Contract Change Order # 1

Project Name: <u>Portland Cement Concrete Street Repair</u>	Project Number: <u>Bid No. 16.126 A</u>
Project Location: <u>City of Broken Arrow</u>	Date of Application: <u>Wednesday, May 31, 2017</u>
Contractor: <u>Cherokee Pride, Inc.</u>	Submitted By: <u>COBA</u>

Summary of Change in Scope of Work

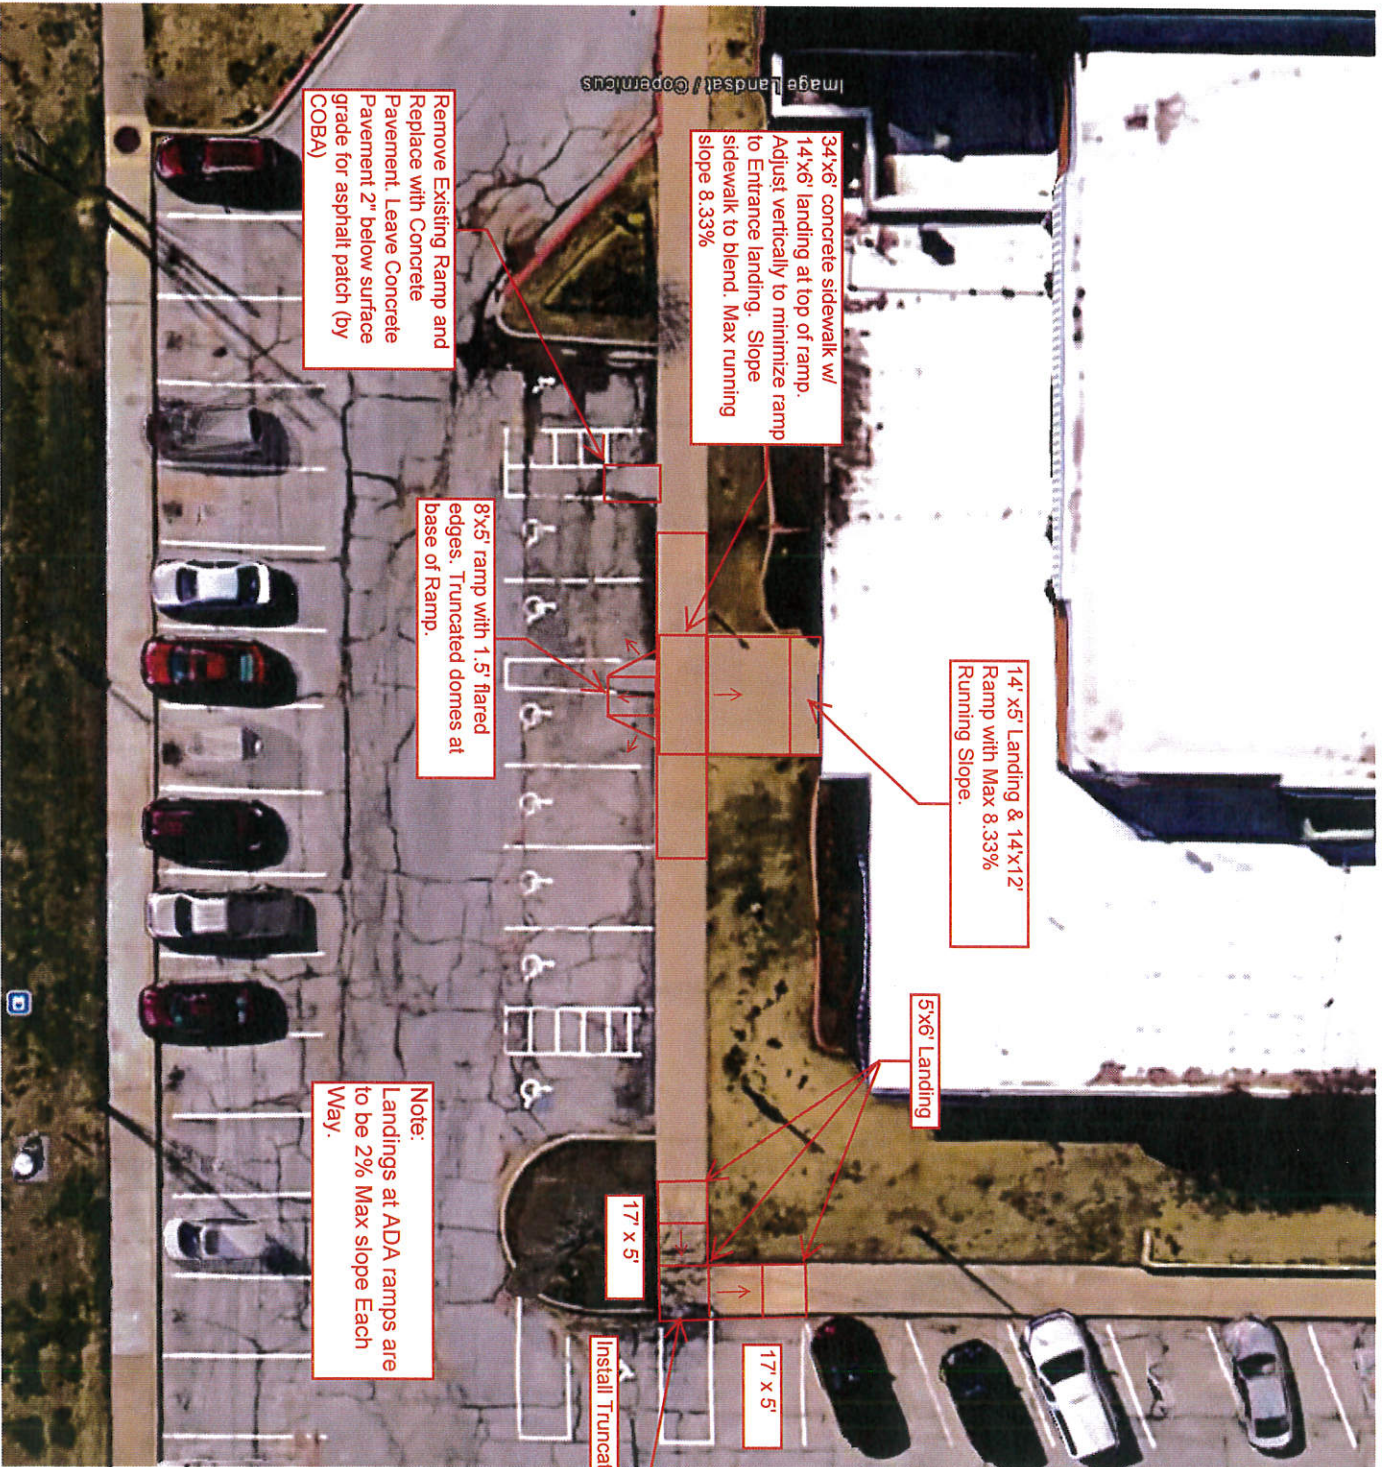
34'x6' concrete sidewalk w/
14'x6' landing at top of ramp.
Adjust vertically to minimize ramp
to Entrance landing. Slope
sidewalk to blend. Max running
slope 8.33%

14' x5' Landing & 14'x12'
Ramp with Max 8.33%
Running Slope.

8'x5' ramp with 1.5' flared
edges. Truncated domes at
base of Ramp.

Remove Existing Ramp and
Replace with Concrete
Pavement. Leave Concrete
Pavement 2" below surface
grade for asphalt patch (by
COBA)

Note:
Landings at ADA ramps are
to be 2% Max slope Each
Way.

PC Concrete Contract 2016-2017
 Work Order - WO-029
 Carriage Crossings Sidewalk

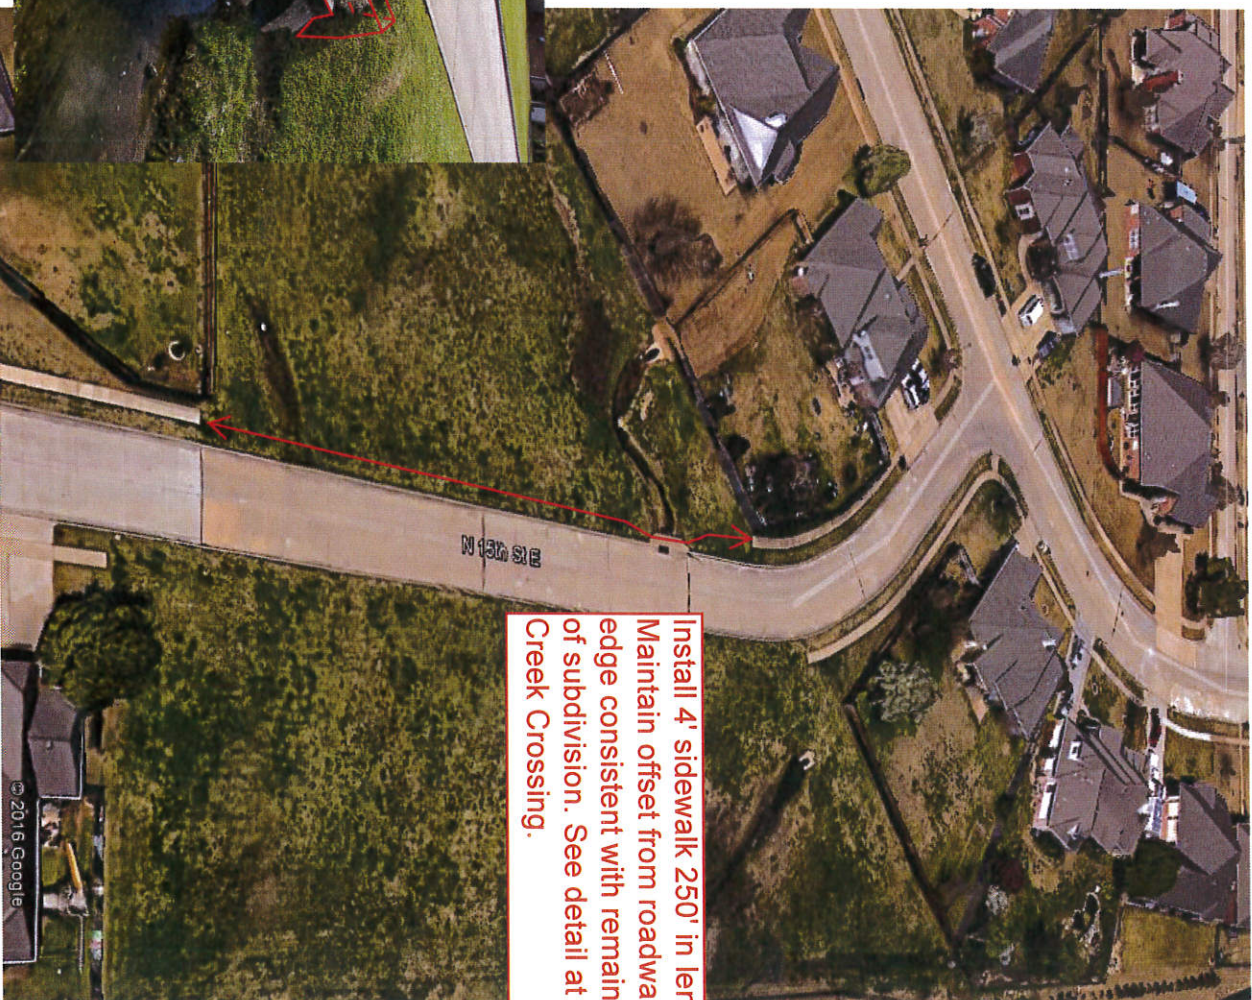
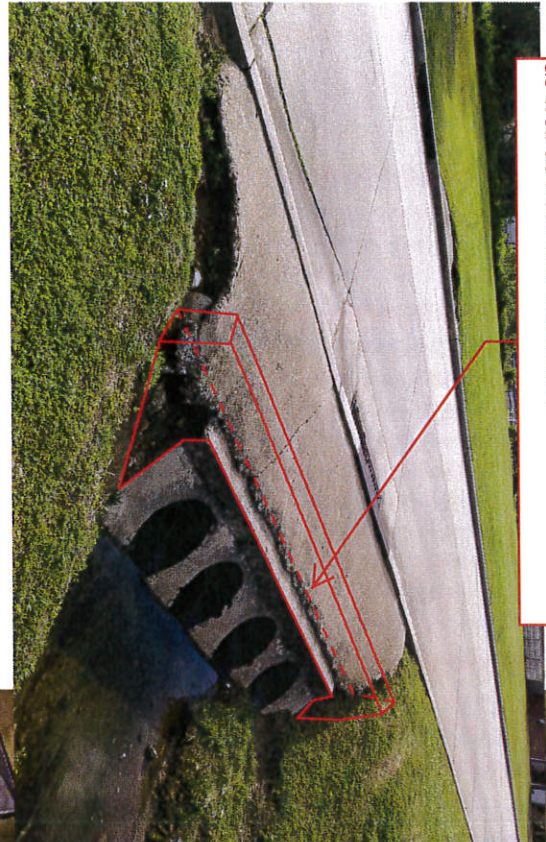
Install 4' sidewalk 250' in length. Maintain offset from roadway edge consistent with remainder of subdivision. See detail at Creek Crossing.

PC Concrete Contract 2016-2017
Work Order #31 - Work Order Extents

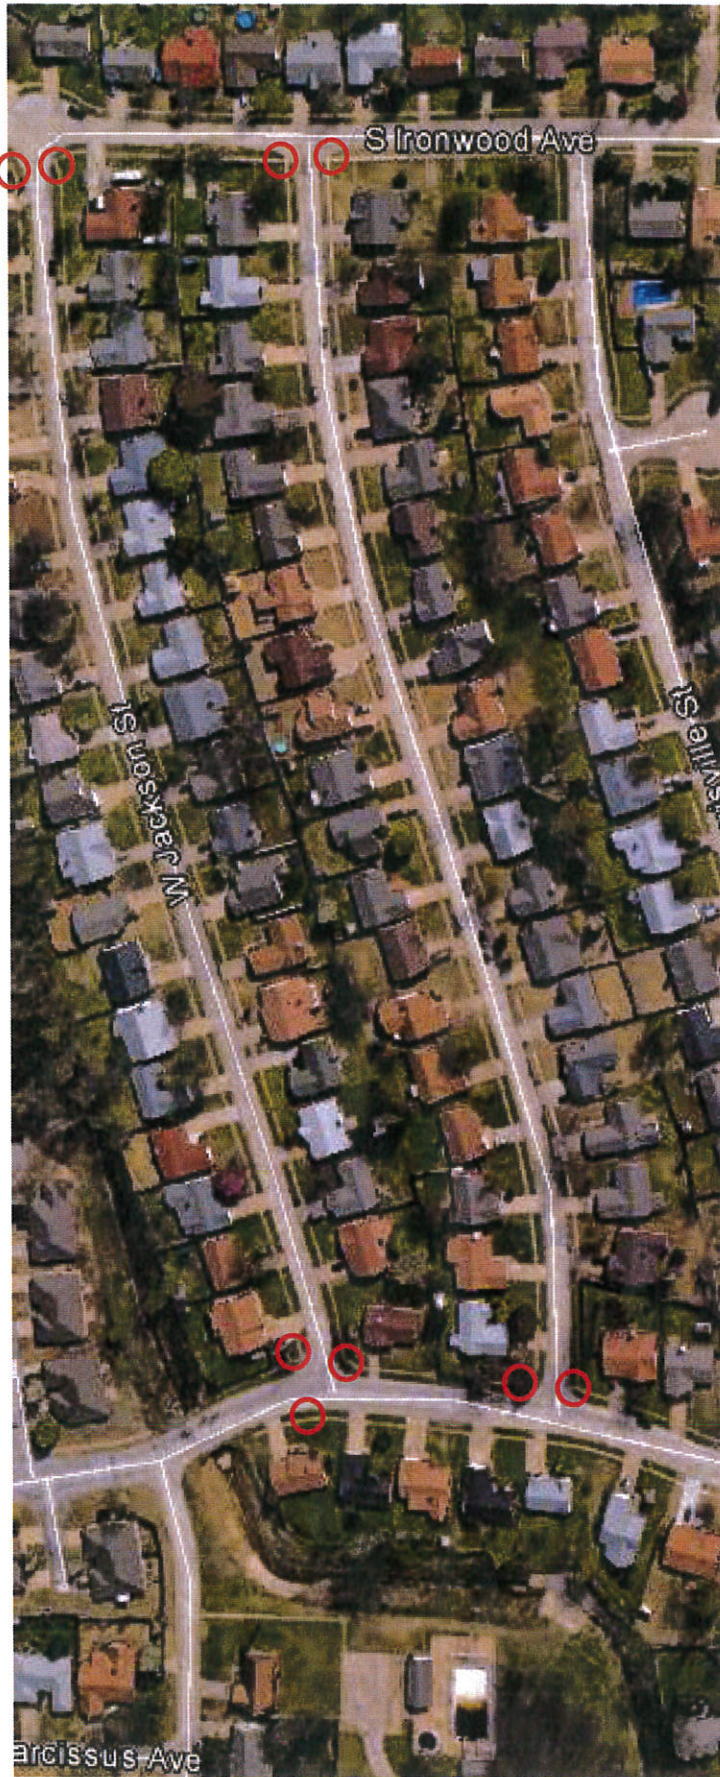
809 S. Lions Ave - NW Crn
1252 W. Jackson St - SW Crn
1101 W. Jackson St. - NE Crn
1100 W. Knoxville St. - SE Crn
1101 W. Knoxville St. - NE Crn
1252 W. Knoxville St. SW Crn
901 S. Lions Ave. - NW Crn
913 S. Lions Ave. - SW Crn

PC Concrete Contract 2016-2017
Work Order #33 - Work Order Extents
Central Park Estates - 81st & Elm

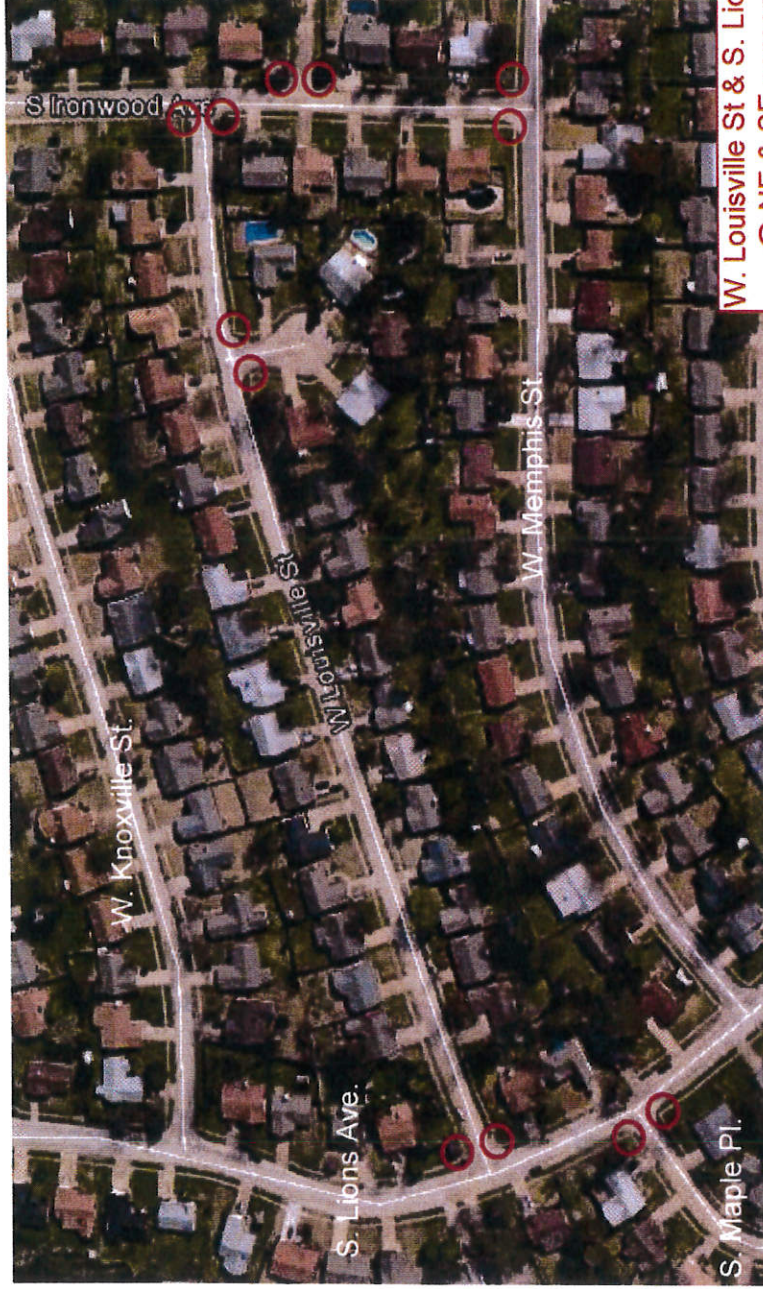
- Install Type "B" ADA Ramps.
- Install sidewalk and curb and gutter as required to make ramp ADA acceptable.

W. Louisville St & S. Lions Ave.
@ NE & SE corners
W. Louisville St. & Ironwood Ave.
@ NW & SW Corners
W. Louisville St. @ Deadend Street
@ NE & SE Corners
W. Memphis St. & Ironwood Ave.
@ NW & NE Corners
S. Maple Pl. & S. Lions Ave.
@ NW & SW Corners

PC Concrete Contract 2016-2017
Work Order #31 - Work Order Extends

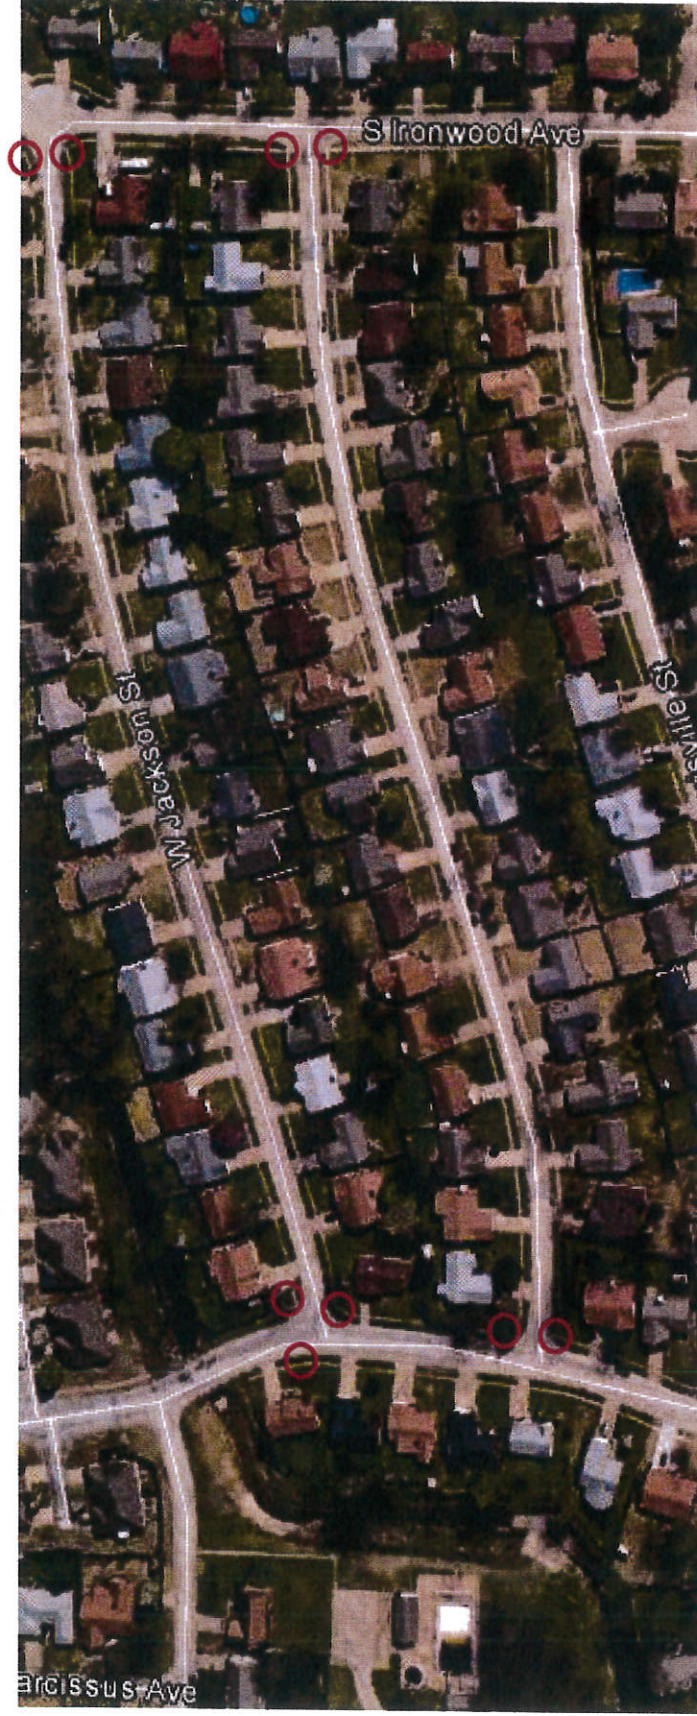
809 S. Lions Ave - NW Crm
1252 W. Jackson St - SW Crm
1101 W. Jackson St. - NE Crm
1100 W. Knoxville St. - SE Crm
1101 W. Knoxville St. - NE Crm
1252 W. Knoxville St. SW Crm
901 S. Lions Ave. - NW Crm
913 S. Lions Ave. - SW Crm
